RE: *Black Mountain Vegetation Management Project Final Environmental Impact Statement and Draft Record of Decision Objections*

Black Mountain Vegetation Management Project

Final Environmental Impact Statement – Objections

Objections Filed by Central Oregon LandWatch

Figure 2 – Main Issue Topic 1.0 Objection. Relative abundance of redband trout declines many fold as stream temperatures increase (from Stuart et al. 2007).

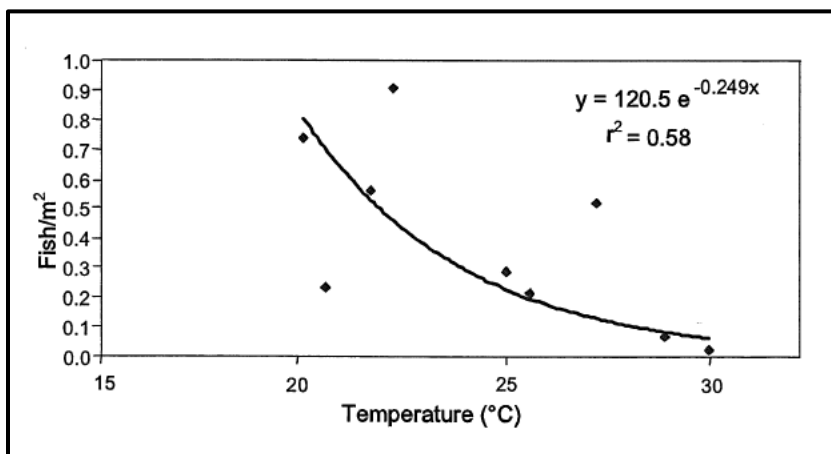
Studies have well demonstrated the impacts of stream temperatures on aquatic organisms. Higher stream temperature impacts aquatic species by raising stream temperatures above the tolerable range for rearing, and increases vulnerability to disease, reduces metabolic efficiency, shifts fish species assemblages, and inhibits upstream migration (Beschta et al. 1987; Hicks et al. 1991). After flow, high summer water temperatures are probably the second largest factor affecting fish in the Crooked River basin (Stuart et al. 1996). Optimal stream temperatures for rainbow trout are 54°F to 64°F. Water temperatures in headwater streams on the ONF often exceed 70°F and have been recorded as high as 83°F, well in excess of state water quality standards for the Deschutes River basin (Stuart et al. 1996).

Habitat conditions on the ONF indicated that many streams were in poor condition with high summer water temperatures, suboptimal shading and lack of large wood, due to past and present forest management activities (Stuart et al. 2007). The authors' study of the Crooked River basin and streams on the ONF indicated that many streams had high temperatures. Their data indicated that redband trout are highly susceptible to increasing water temperatures and exhibit swift declines in abundance as stream temperatures increase, one of the parameters for redband survival and persistence.

These small populations of redband trout are at risk of extirpation during drought conditions and from climate change bringing warmer and drier conditions. This risk is particularly significant because Allen Creek and Peterson Creek are disconnected from the North Fork Crooked River and any other streams in the basin by dams downstream of the project area. This risk was documented on Double Cabin Creek in the Maury Mountain in the southern part of the Ochoco Mountains in 1994, when extreme drought conditions extirpated redband trout in this small stream that was disconnected from other streams by dams downstream on private lands. The future of redband trout populations in Allen and Peterson

Figure 1 – Main Issue Topic 2.0 Objection. Porter Creek area north of Deep Creek Campground (Source: Ochoco National Forest 2015, 1989, respectively).

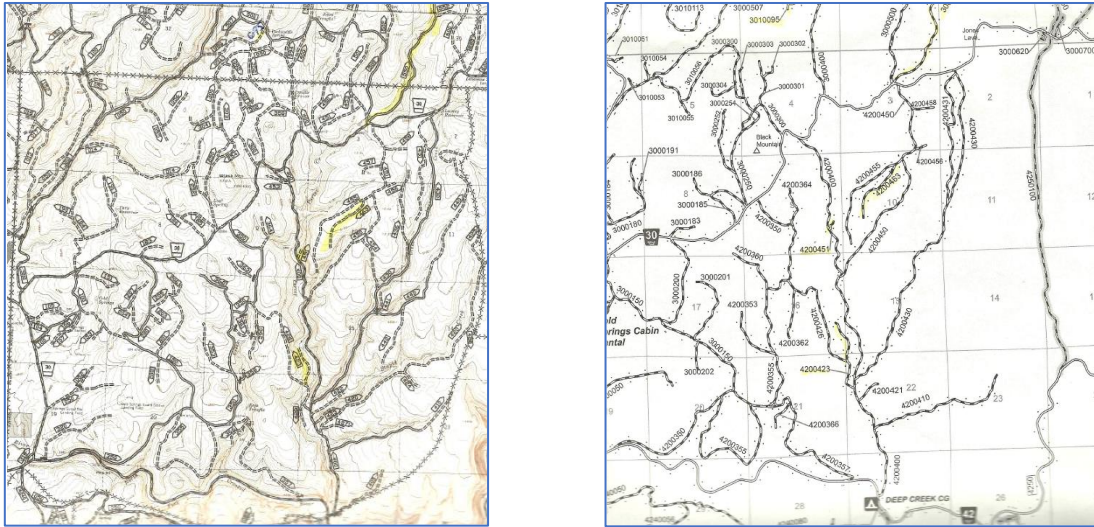
Actual road densities (ML 1-5) in Peterson Creek watershed, at the subwatershed level, are 3.2 miles/square mile, and in the sediment delivery zone (i.e., within 300 feet of streams) are even higher at 4.3 miles/square mile (U.S. Forest Service 2014 at Page 138) (this subwatershed includes Allen Creek). Similarly, current road densities (ML 1-5) in the Porter Creek subwatershed are 3.7 miles/square mile and 7.4 miles/square mile in the sediment delivery zone. These road densities are higher than the forest standard and excessively so in RHCA's.

The following maps depict the differences in road densities mapped in the Porter Creek area north of the Deep Creek Campground, and those mapped on the Motor Vehicle Use Map (MVUM). The MVUM shows only “open,” ML 2-5 roads; and a 1989 administrative use map shows all the roads on the landscape in 1989 (Figure 1 – Main Issue Topic 2.0 Objection). In the past 30 years, many more miles of roads have been added so the administrative map does not show the full extent of roads on the landscape.

As detailed below, road densities are important because they increase the hydrologic connectivity between uplands and riparian areas and streams creating new “pathways” for flow and sediment to reach streams. They also increase the amount of peak flow causing higher peak flows and therefore flood events that are beyond the normal range of variation. Therefore, these events increase scour and loss of soils, degrade bank stability, and increase fines and sediment in stream beds and fill in pool habitat.

1. Instruct the Responsible Official to revise the affected environment to accurately disclose the total amount of road density and use within the project area and on the ONF. Assess the densities of all ML 1-5 roads (closed, decommissioned, temporary, reconstruction roads, and user-created trails). Once accurately described, explain how road densities meet forest standards.
